**NSLPP MEETING HELD ON 04/12/2024
SECTION 4.55 APPLICATION REPORT**

ADDRESS: 58 Cowdroy Avenue Cammeray

APPLICATION No: D60/22/2

PROPOSAL: To modify a consent for demolition of existing dwelling and ancillary structures and construction of a dwelling house and associated works including a swimming pool.

Below is a series of section-extracts which illustrate the sequence of design adjustments to the roof, from:

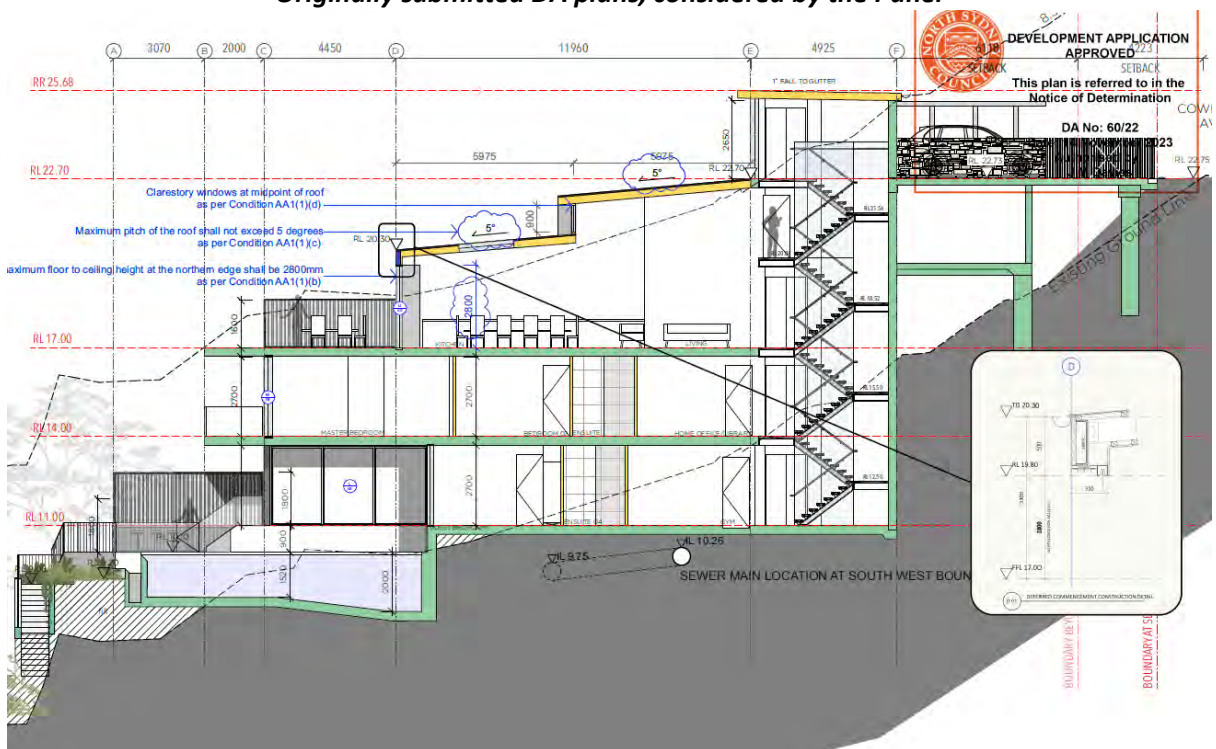
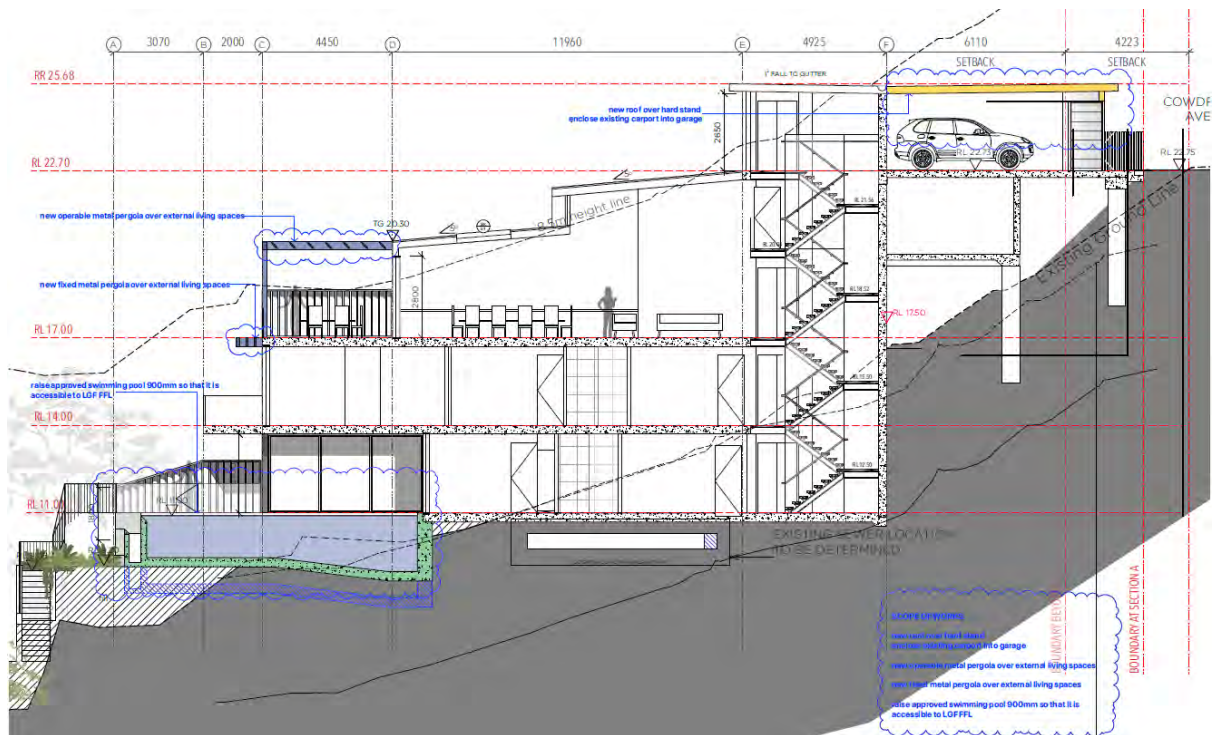
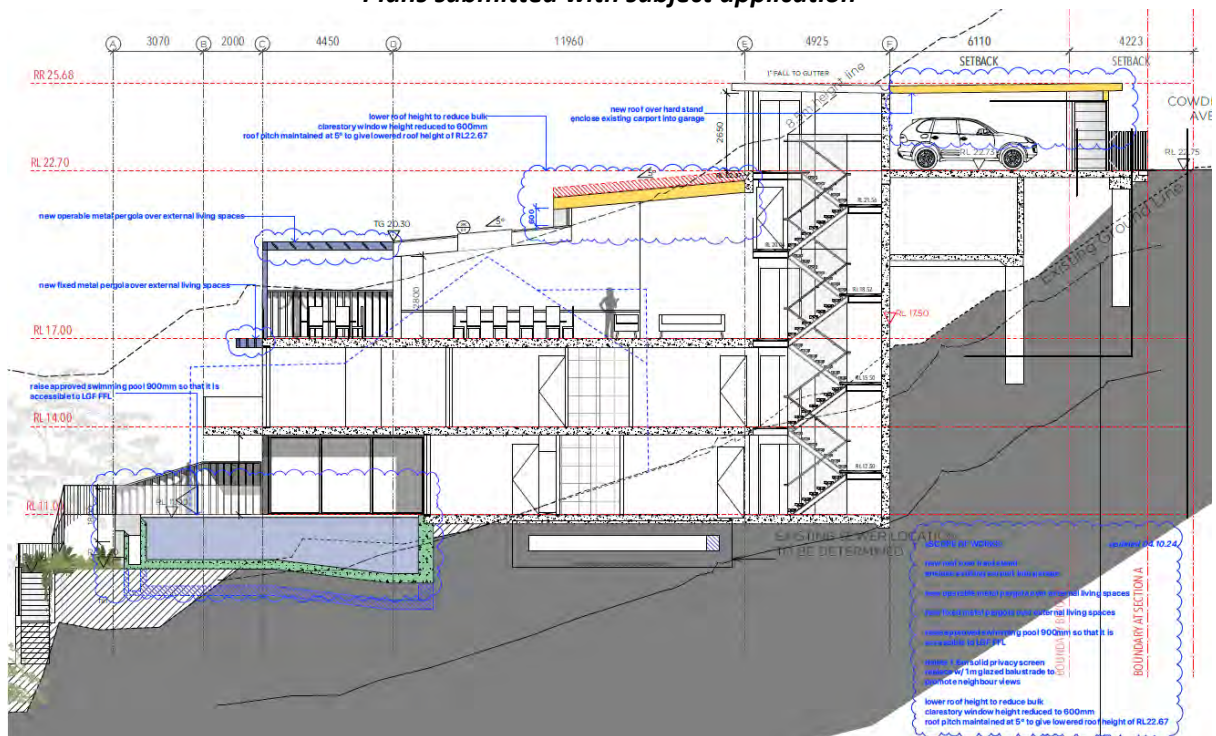
Deferred commencement condition AA1 (1) required the roof to be adjusted to lower its overall height and provide a clerestory window in the roof's centre to break up the size of and therefore articulate the roof plane. The condition also stipulated that the floor below must not have a floor to ceiling height of more than 2.8m and that the roof angle not exceed 5 degrees above horizontal.

Plans were submitted and subsequently approved, having been assessed as satisfying the deferred commencement conditions. These plans show the height of the upper section of the roof to create an effective clerestory, with a window height of 900mm, and to maintain the maximum ceiling height of 2.8m, as required by the Panel's deferred commencement condition.

Plans submitted with the subject modification are consistent with the height approved when operational consent was issued. Following notification and consideration of submissions, the above was discussed with the applicant, who later submitted plans lowering the height of the clerestory from 900mm to 600mm, reducing the upper roof plane's height.

DRAWING NAME. **SITE PLAN**

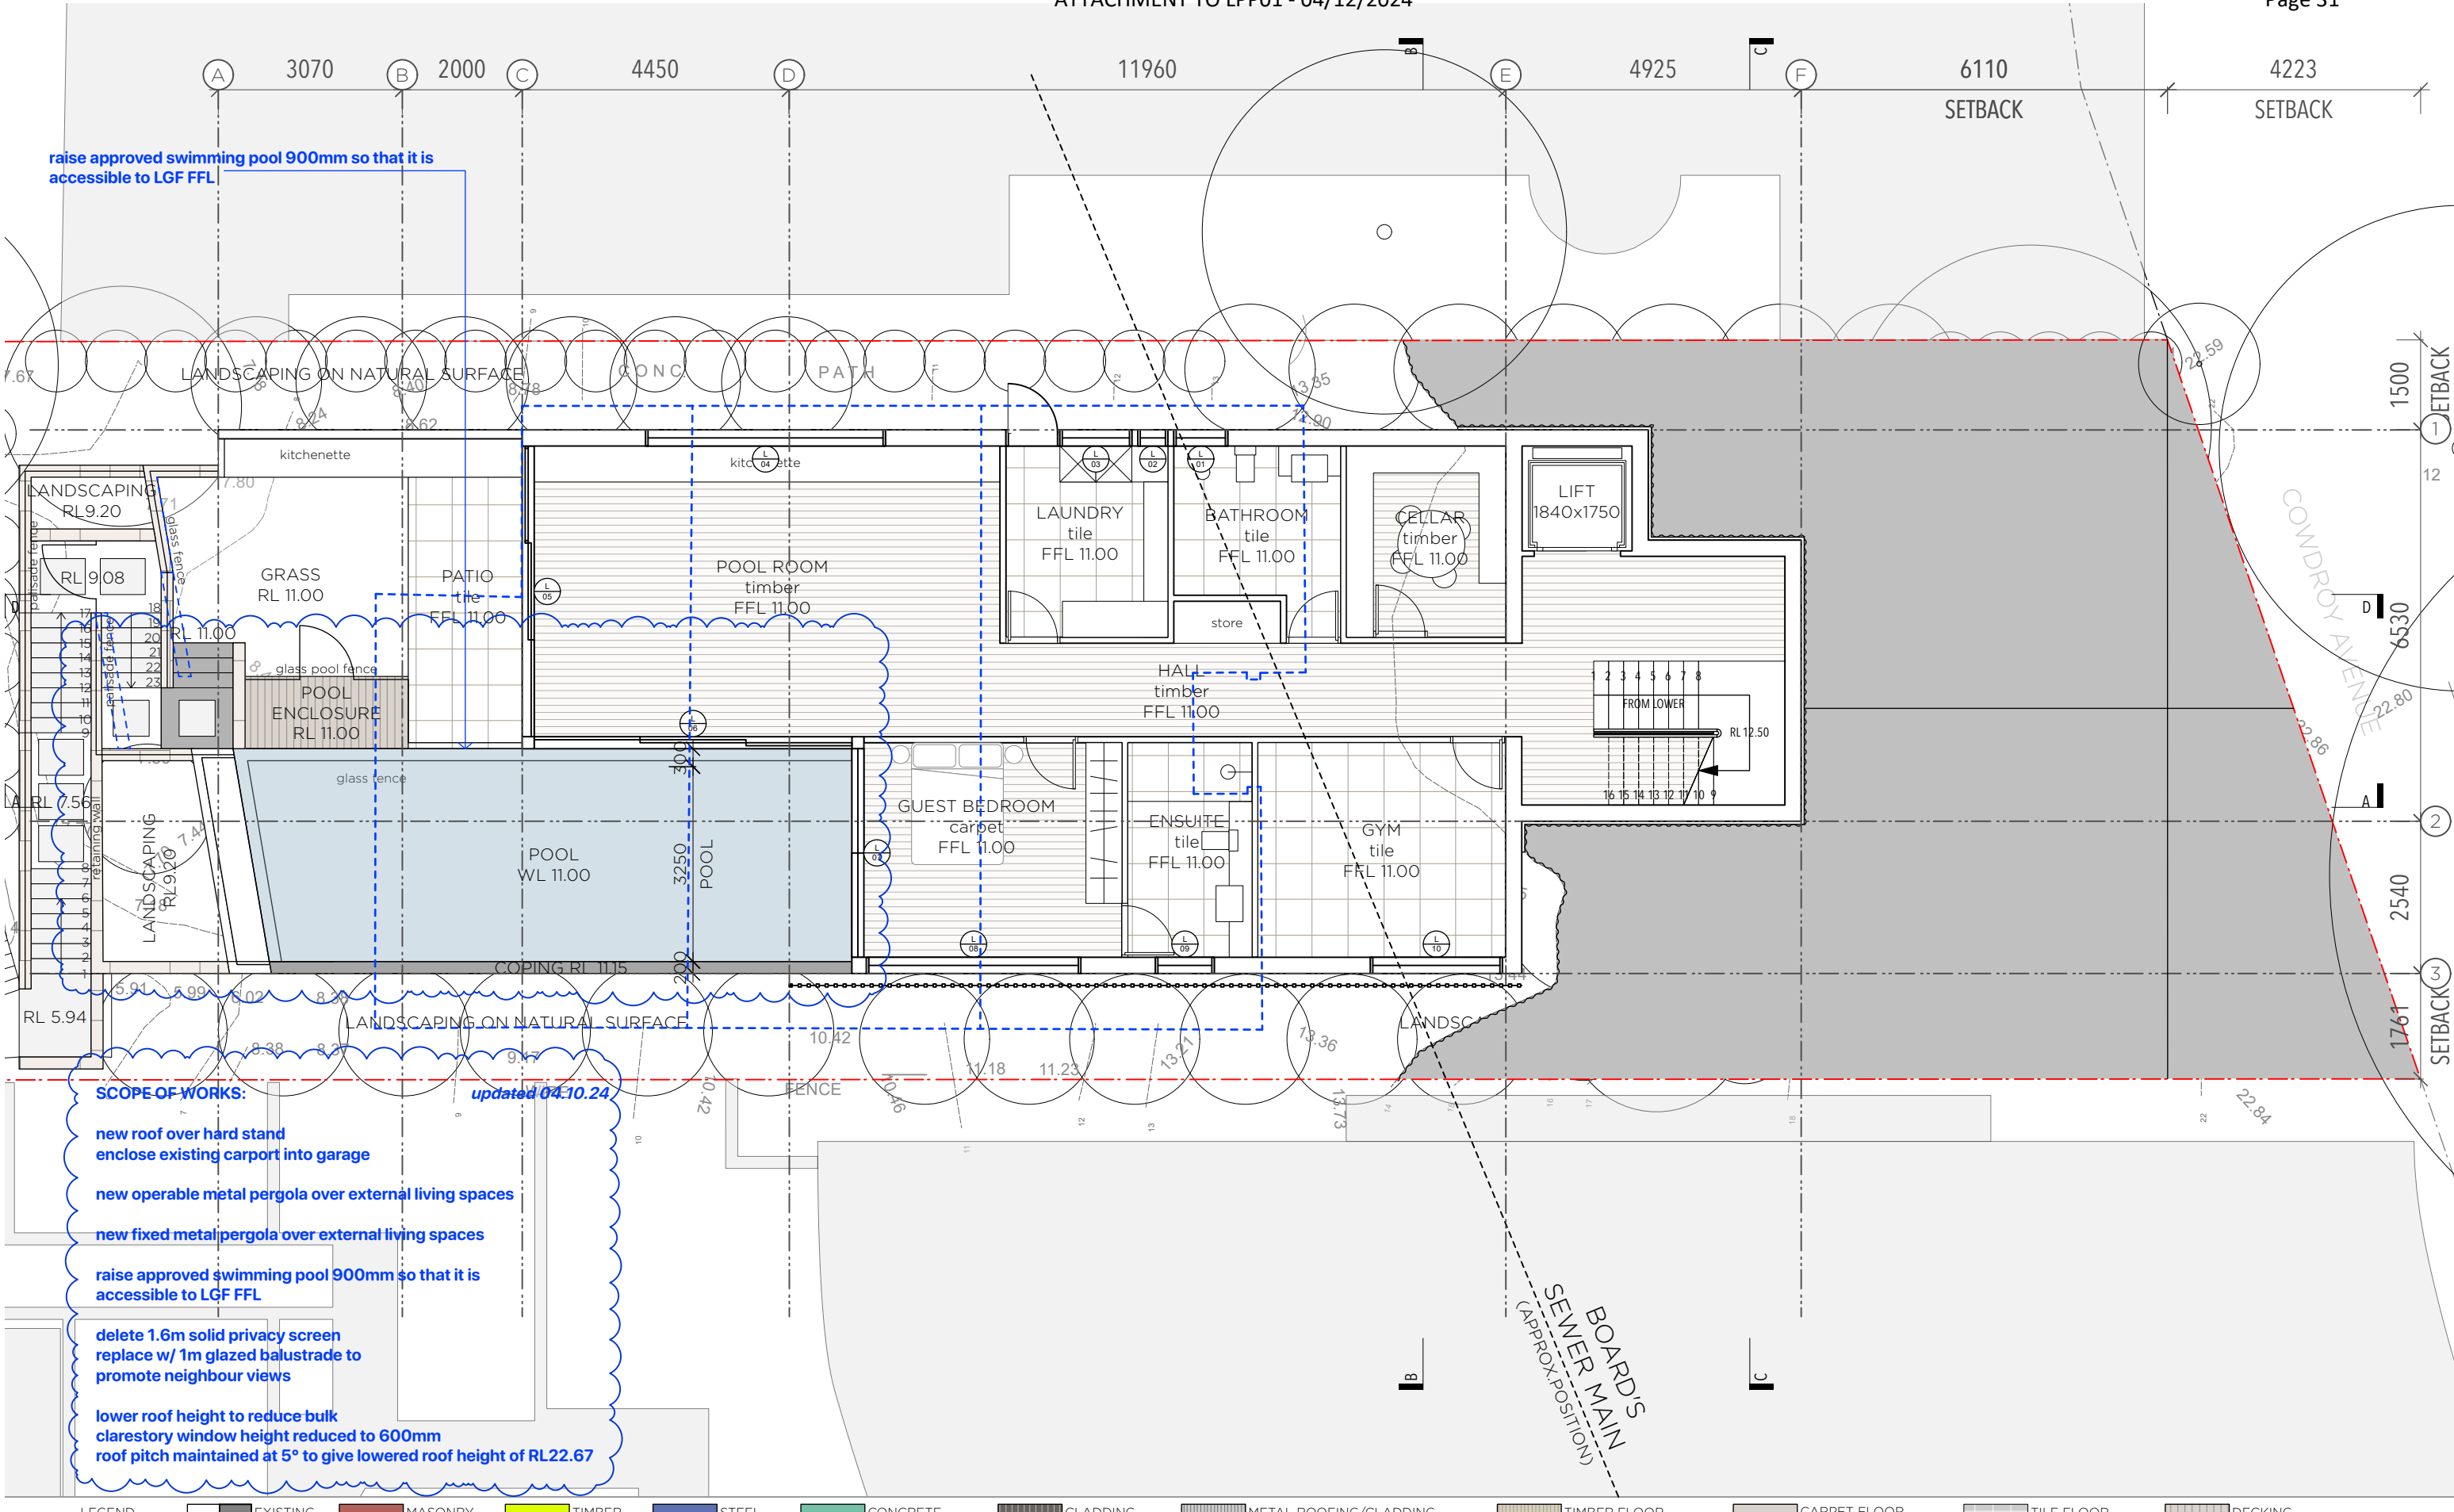
The subject modification application, referring to the submitted statement of environmental effects, does not change the approved figures. This statement is incorrect.

Taking abovementioned planning objectives into account, to balance built form and open space, prevent over development and promote desired character, the proposed conversion of the parking area into a garage should not be supported.

- m) *the open parking area must remain as approved, the garage as shown in submitted plans, referred to in the amended condition A1, is not approved.***

DRAWING NAME.
UPPER LEVEL FLOOR PLAN + 3m

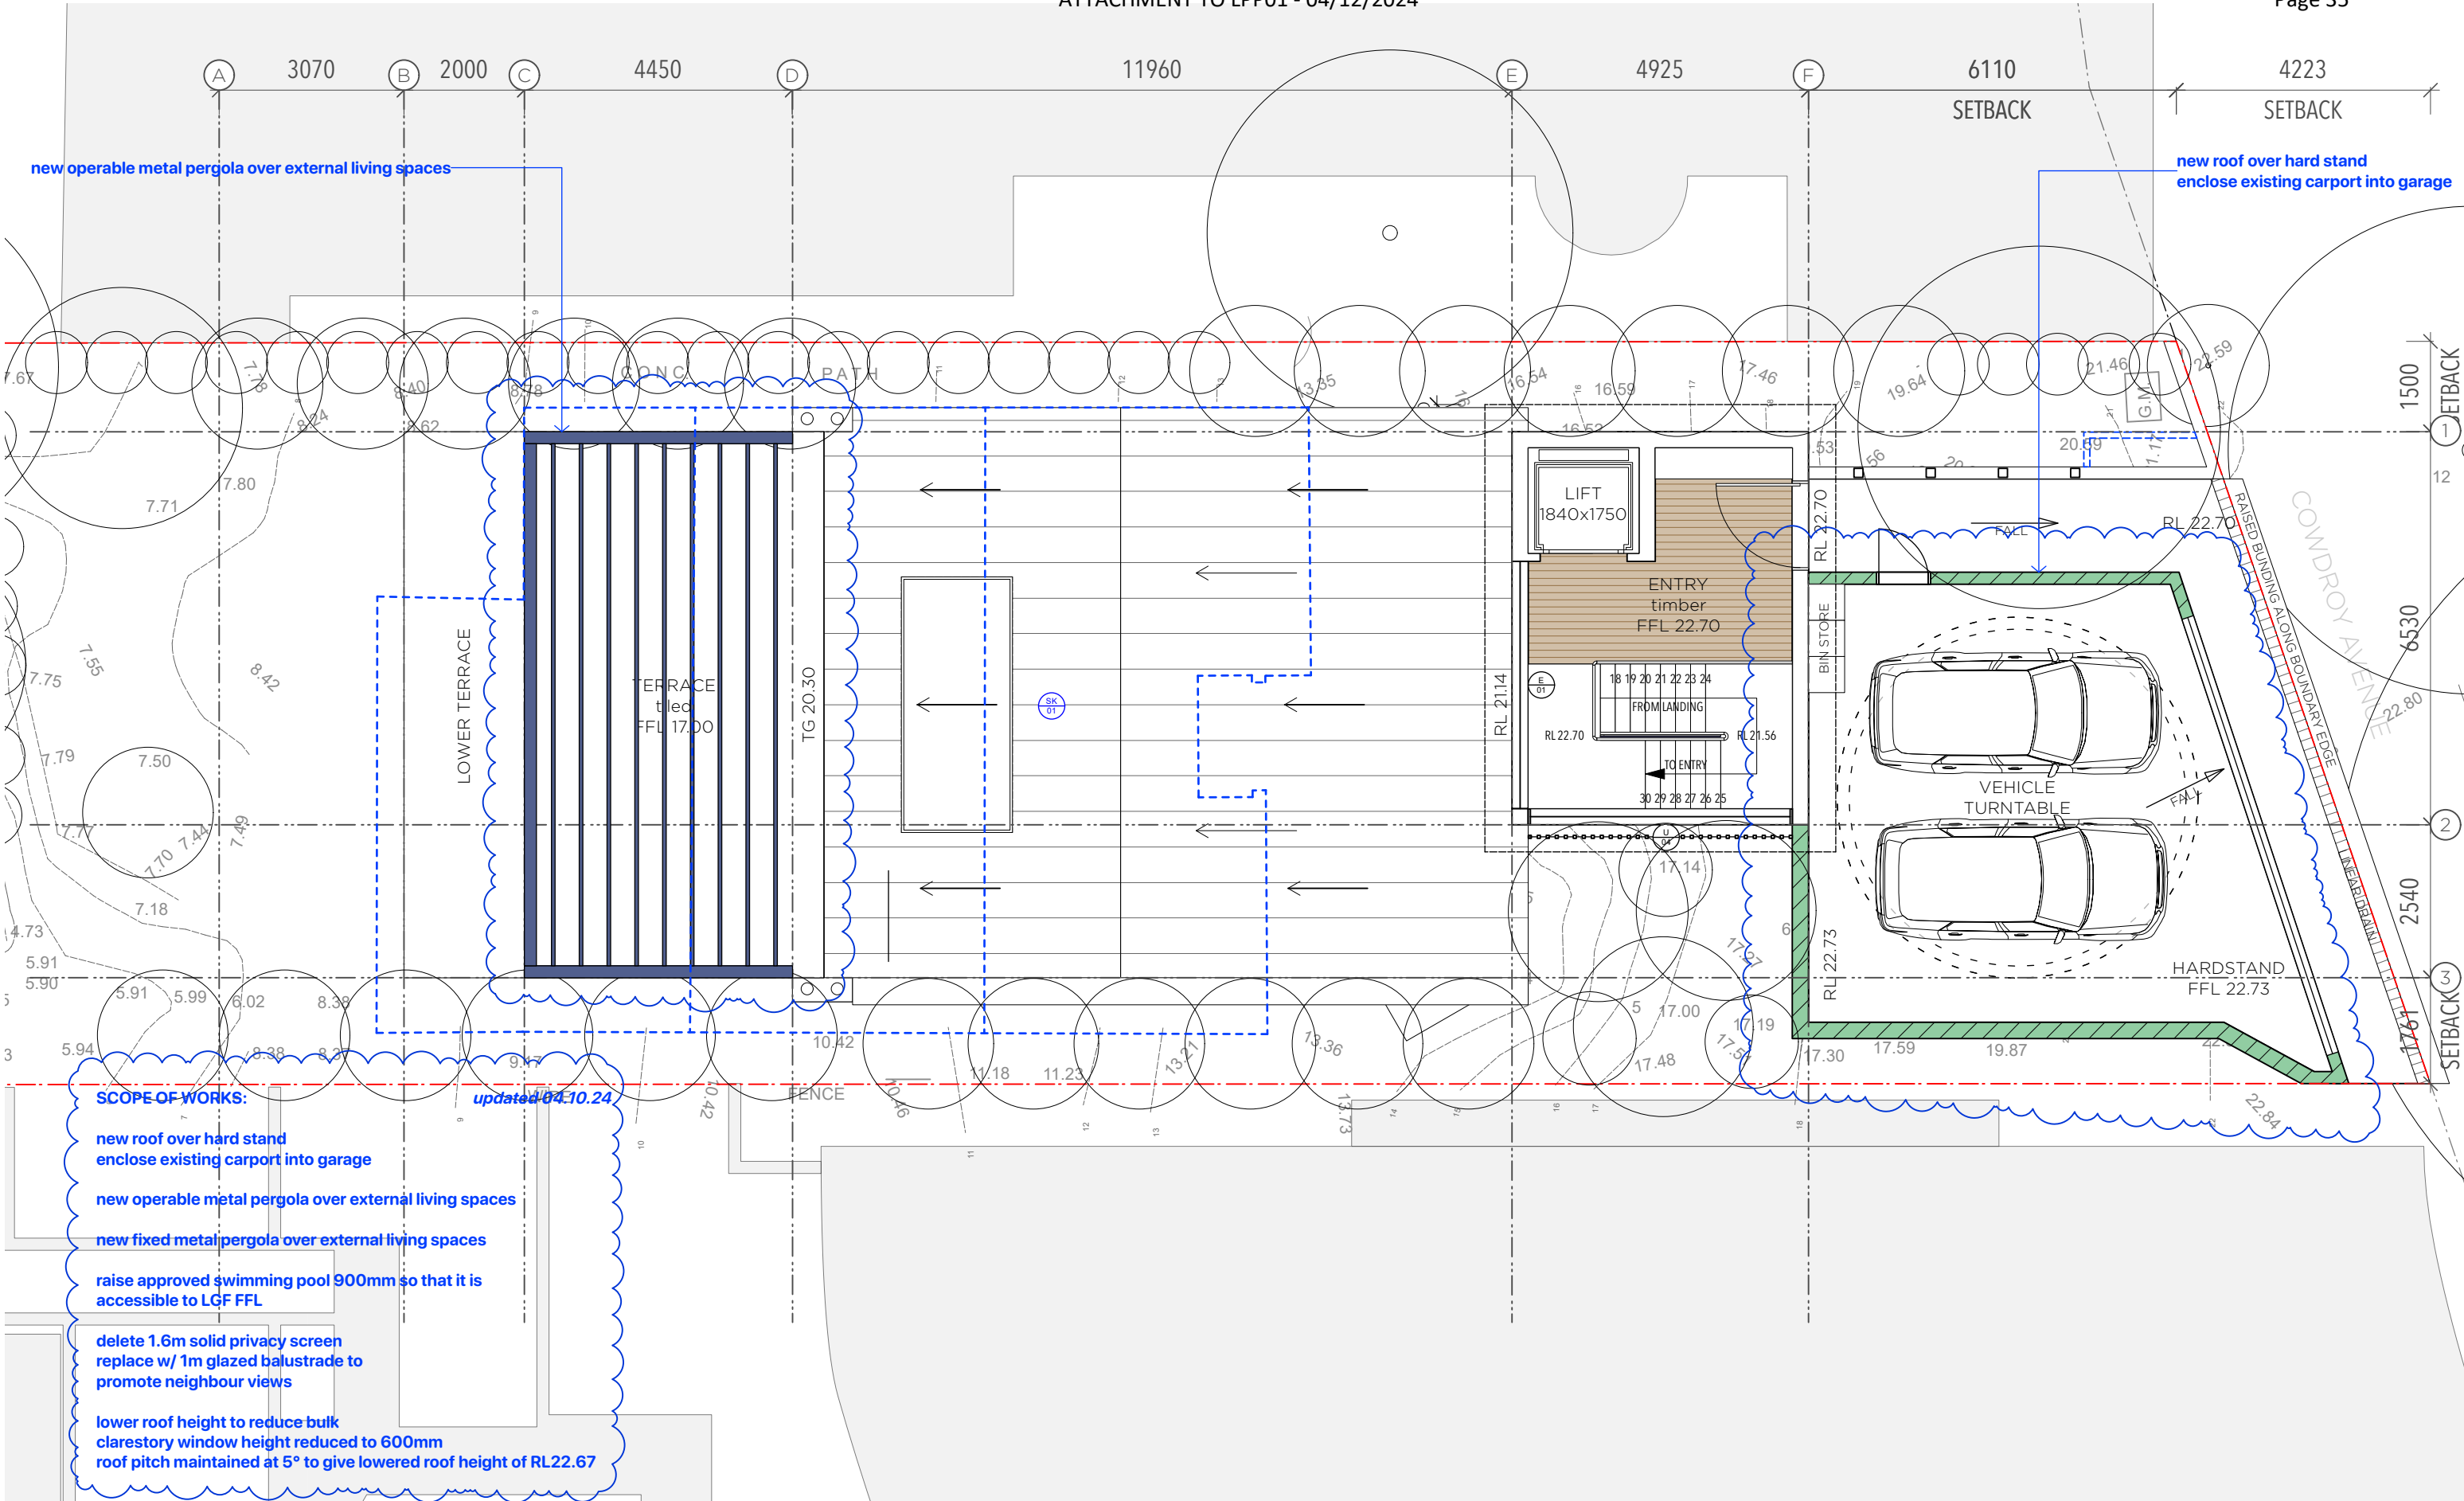
The view impacts arising from the proposed pergola to the Upper Floor Level terrace are addressed in detail below, having regard for relevant view sharing principles, however it is considered that the new structure is not consistent with the reasons given in the original Panel's decision to support the proposal.

On this basis that impact on views is not supported and it is recommended that the Pergola Structure be deleted. To achieve this, it is recommended that Condition C1 of the consent be amended to delete this structure.

The change from a privacy screen to a glass balustrade on the western side of the terrace on the upper level will affect privacy with the dwelling at 56 Cowdroy Avenue. The effect is reasonable given the change in materials (solid to transparent) and height (lower) will help maintain views for occupants of the proposed dwelling and the neighbouring dwelling over the shared boundary.

- a) **A Louvred/slatted privacy screens** a minimum 1.6m high from finished floor level shall be affixed to the eastern ~~and western~~ edges of the balcony to the Upper Level (Level 03) adjacent to the open plan living room to obscure direct lines of sight between the balcony and the neighbouring properties ***east of the site, and the balustrade on northern and western sides of the balcony being finished in clear, unframed glass;***
